BURGER 4KV O/O BICKNELL SUB

DISTRICT 22 - MONTEBELLO		PROJ. MGR. ALATORRE, ELDA M PHONE 323-720-5214		PLANNER ALATORRE, ELDA M PHONE 323-720-5214			
FOREMAN		TRUCK NO. P/E		INVENTORY MAP NO. THOMAS GUIDE 122-4236-1		GRID NO. DESIGN NO. 648771_0.01	
CSD 140	Y <input type="checkbox"/> N <input type="checkbox"/>	BY-PASS CODE	EXISTING CHANGE TO	TLM CHECKED	%LOAD	J.P.A. NO.	ASSOCIATED DESIGN NO.
PRODUCT/SAP NO. 933212-RELOCATE FACILITIES(FUNCTION WORK ONLY)				PRODUCT/SAP NO.		PRODUCT/SAP NO.	
				PROPOSED CONSTRUCTION (LOCATION) RELOCATE DOWN GUY 4506 6TH LOS ANGELES CA 90022 LOS ANGELES			
TYPE	APPROVED BY	DATE	CHECKED BY	DRAWN BY	PAX #	SHEET 1 OF 1	JOB NO. 648771_0.01
Southern California Edison Company

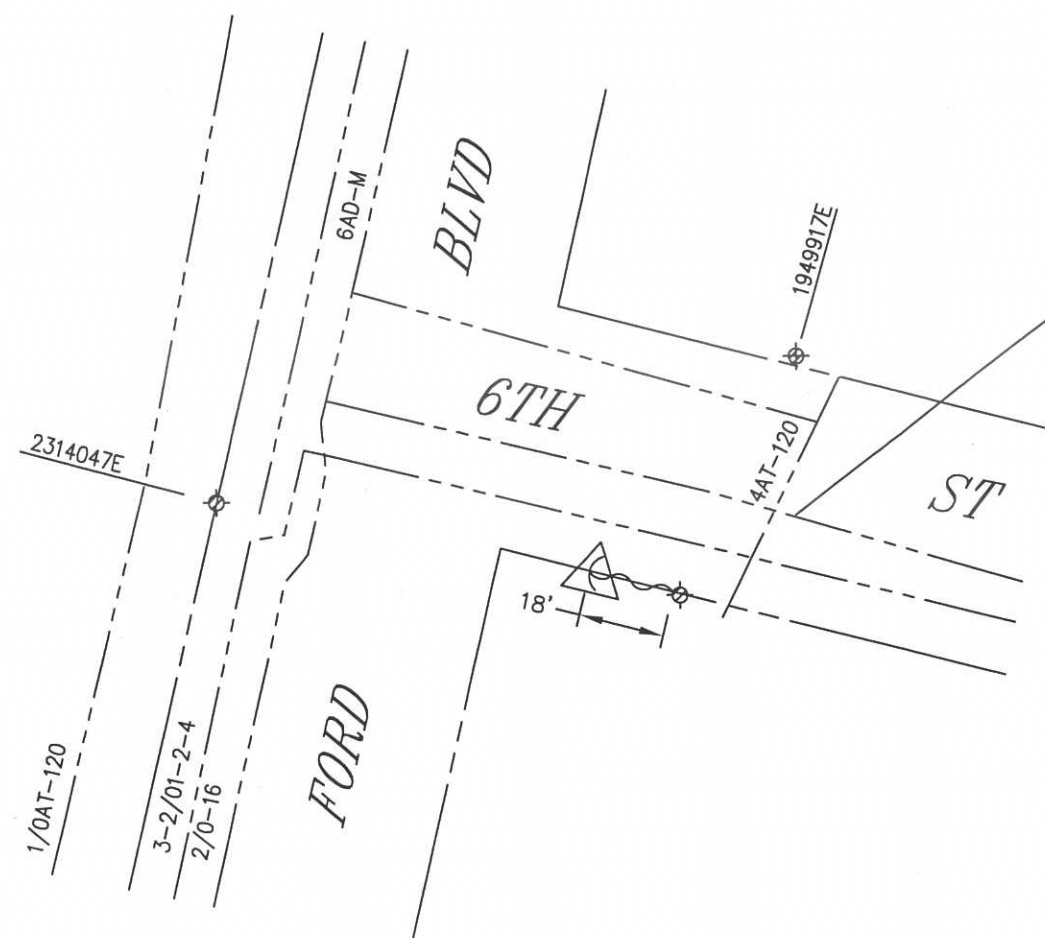
*Markup are provided merely for
visualization purpose and are not to be
interpreted as being exactly to scale.
(Arrows indicating which side of the BCR
the down guy will need to be relocated to.)

- NOTES:**
- RELOCATE EXISTING DOWN GUY 18' FROM EXISTING POLE.
 - PLEASE TRY TO PUT ANCHOR AS CLOSE TO FENCE AS POSSIBLE.
 - REMOVE & INSTALL NEW ANCHOR

FR: 1- AG ANCHOR ROD 1" X 10' 3-EYE W/PLATE

FR: 3- AG DOWN GUY 3/8" - 50' LESS THAN 22.5KV

FI: 1- AG ANCHOR ROD 1" X 10' 3-EYE W/PLATE

FI: 3- AG DOWN GUY 3/8" - 50' LESS THAN 22.5KV
